MAGNASTOR[®]

FINAL SAFETY ANALYSIS REPORT

Amendment 11
RAI Responses

**FOR REVIEW OF THE CERTIFICATE OF COMPLIANCE NO. 1031,
AMENDMENT NO. 10**

Figure 4.11-13 Three-dimensional Quarter-symmetry TSC Model for PWR
Configuration – XY Plane View

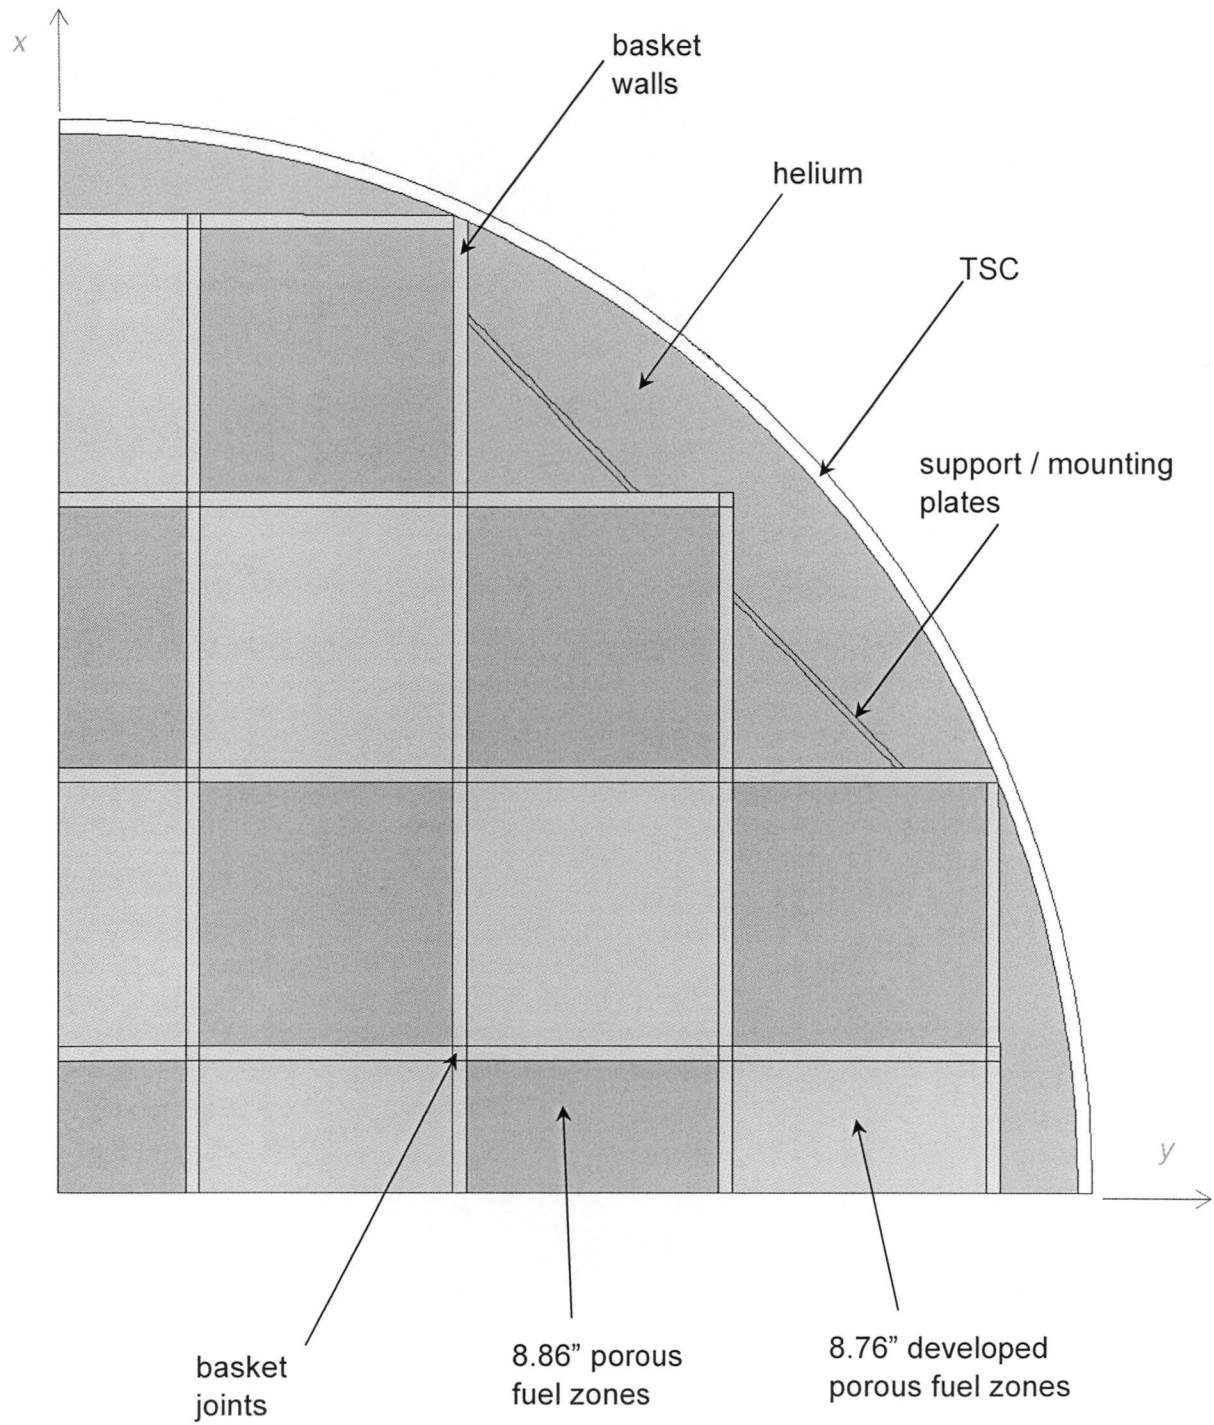
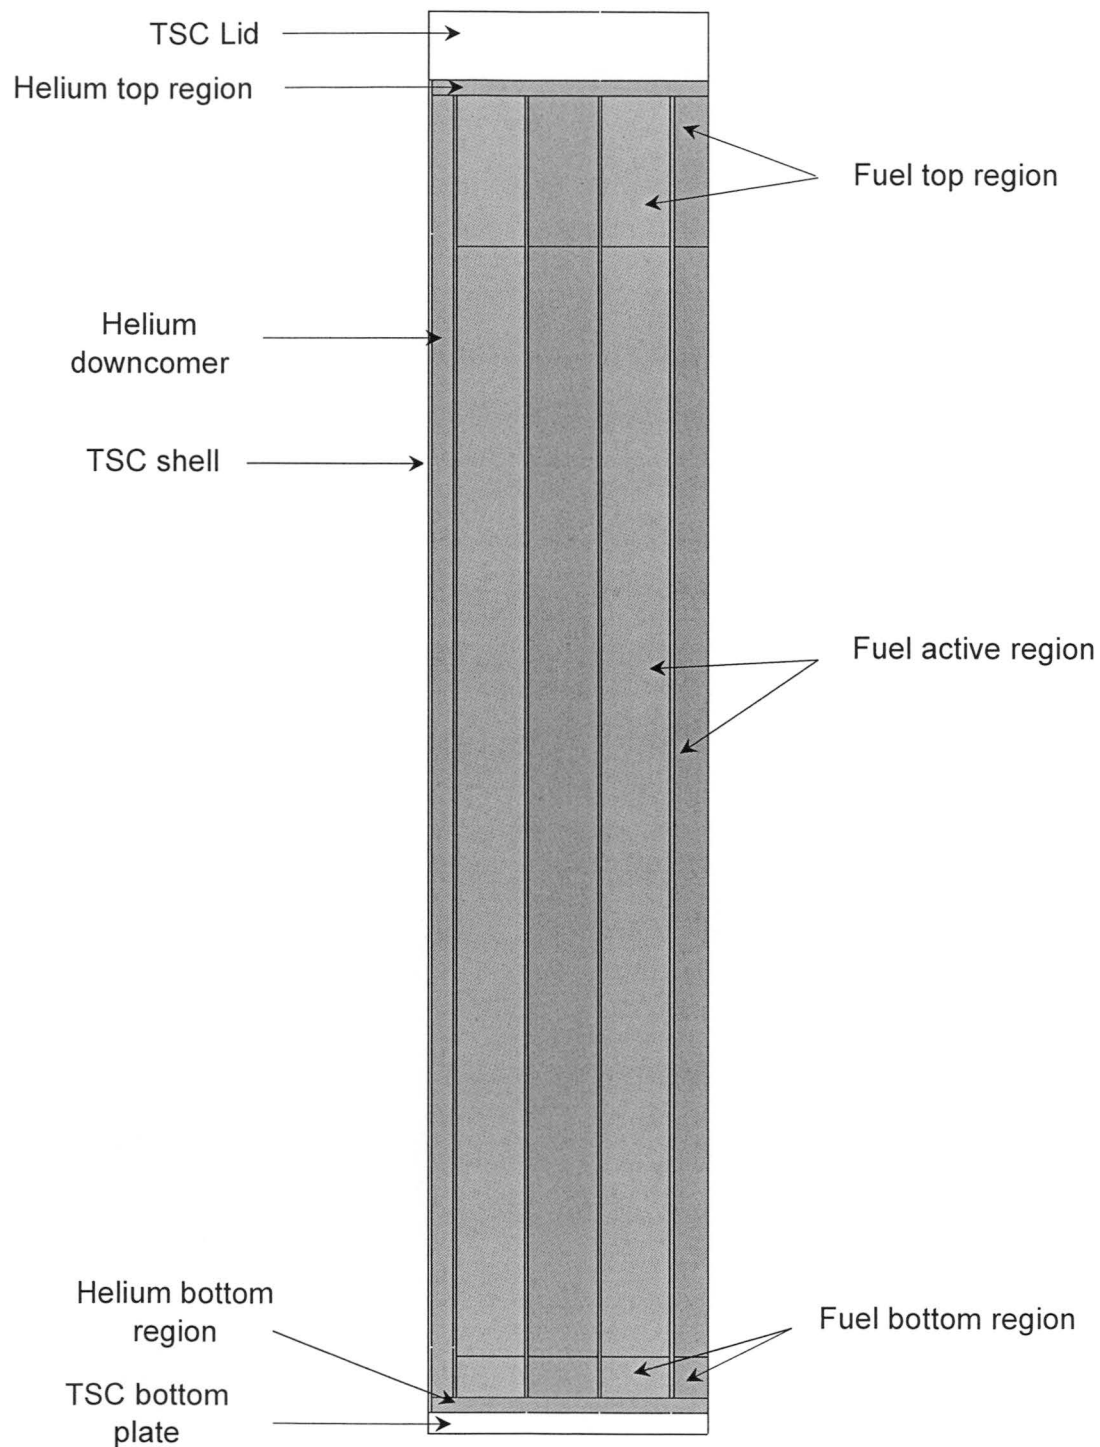
- 4-2 Compare and provide a discussion of the total heat transferred in the two-dimensional (2-D) axisymmetric model presented in Section 4.11.1.1 of the SAR and the quarter-symmetry three-dimensional (3-D) model of the TSC presented in Section 4.11.1.2 of the SAR. Provide a justification for the efficacy of applying heat transfer coefficients calculated from the 2-D axisymmetric model to the 3-D model of the TSC. Provide a discussion of the 3-D model temperature results (including the peak cladding temperature) in light of any discrepancies identified between the two models.

For the PWR configuration, NAC calculation 71160-3085 was revised (to Revision 2) to modify the boundary conditions on the TSC top and bottom surfaces of the three-dimensional TSC model, to ensure that the heat transfer rates between the two-dimensional (2D) and three-dimensional (3D) models agree for all TSC surfaces for the thermal evaluations.

All cases and results of NAC calculation 71160-3085 were updated and the associated FSAR sections (Sections 4.11.2.1.1, 4.11.3, 4.11.4 and 4.11.5) were revised accordingly.
